AGENDA - WORKSHOP OF THE PLANNING AND ZONING COMMISSION OF THE CITY OF PEARLAND, TEXAS, TO BE HELD FEBRUARY 17, 2014 AT 7:15 P.M., IN THE COUNCIL CHAMBERS, CITY HALL, 3519 LIBERTY DRIVE, PEARLAND, TEXAS

- 1. COMMISSIONER INPUT AND DISCUSSION:** REGARDING A PROPOSED PLANNED DEVELOPMENT KNOWN AS LAKE PARK PLANNED DEVELOPMENT – LOCATED AT THE NORTH EAST CORNER OF CULLEN BLVD. AND MCHARD ROAD. *Presented by Lata Krishnarao, Community Development Director*

**AGENDA REQUEST
BUSINESS OF THE CITY COUNCIL
CITY OF PEARLAND, TEXAS**

This workshop is to discuss a request for a Planned Development (PD) to be located at the northeast corner of Cullen Pkwy and McHard Road, referred to as Pearland's Lake Park. The property consists of 47.8 acres of land and is currently undeveloped and zoned Single-Family Estate District (R-E). The area being discussed is located just south of where Pearland's City limits abut Houston, and north of Dawson High School.

LAKE PARK
Overall Land Plan

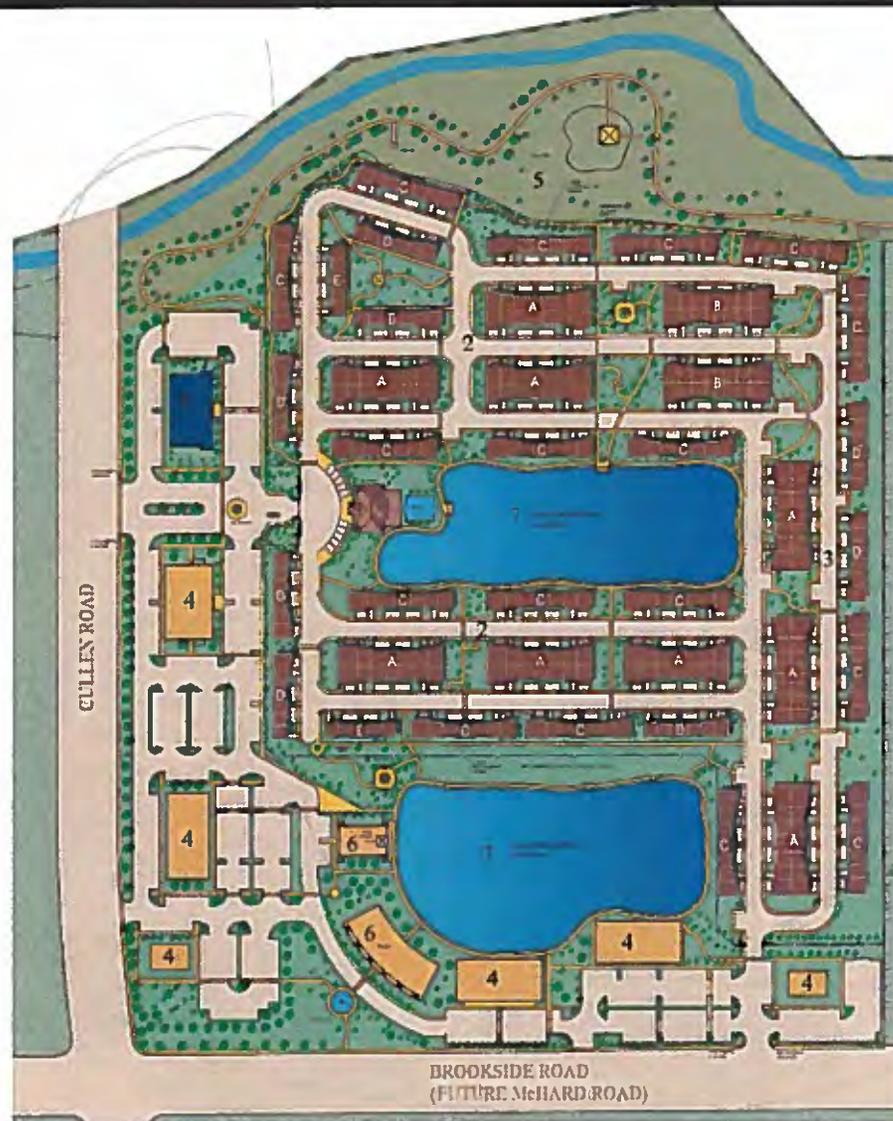
26. Land Use Table- need to add information for all categories. Open space is blank, and Parkland is missing. The total does not add up to the 47.8 acres, as mentioned in other places. Total acreage needs to be consistent in text, plans, and survey.

27. Overall Land Plan – Identify parkland dedication areas and open spaces; label all amenities and structures, Office component not labeled.
28. Residential Density and Multi-Tenant Square Footage table mentioned in Section X is missing.

29. Provide a legend on all the exhibits. For example, what does “A, B, C” and “1, 2, 3...” on these exhibits mean?
30. Building elevations need to be tied to the buildings.

Fence Exhibit

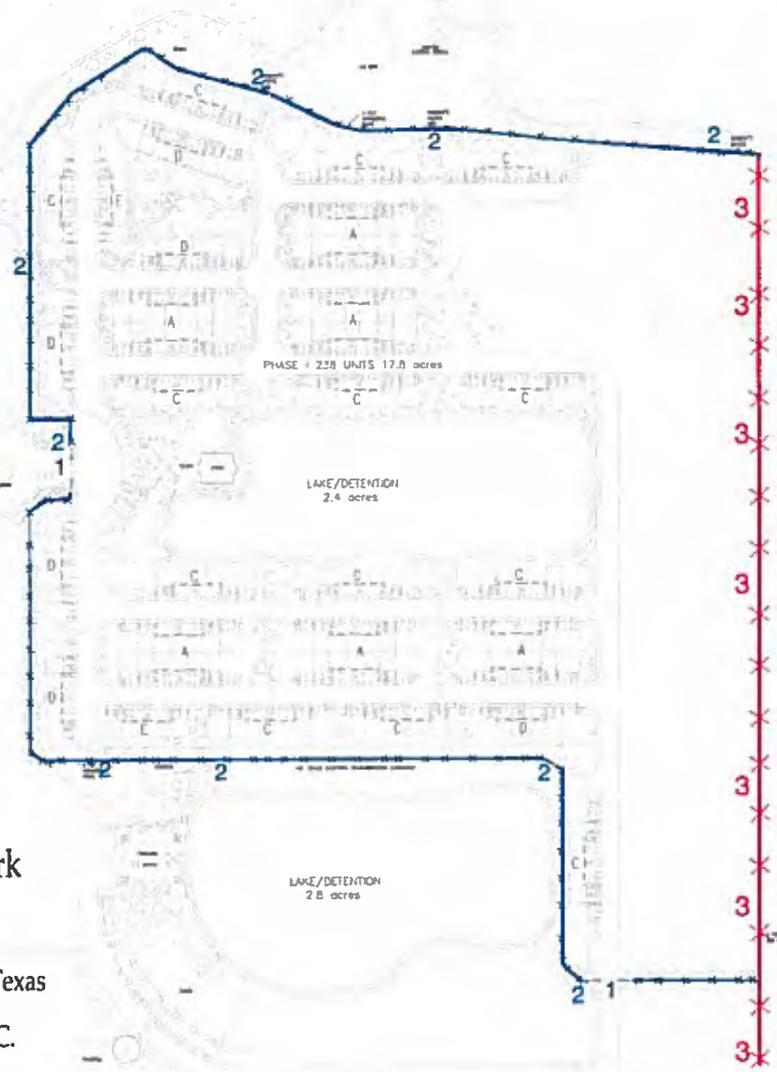
18. Prior to development a detailed drainage analysis and drawings need to be submitted for review and approval of dimensions and locations of proposed detention ponds. Ponds are not approved as shown in the exhibits.

24. Label all exhibits and ensure consistency with the title on plans and various exhibits, with the language within the PD document.
25. Section VII - Clarify where “Parking medians visible to Cullen Blvd. or McHard Road” are. Identify this on plan.
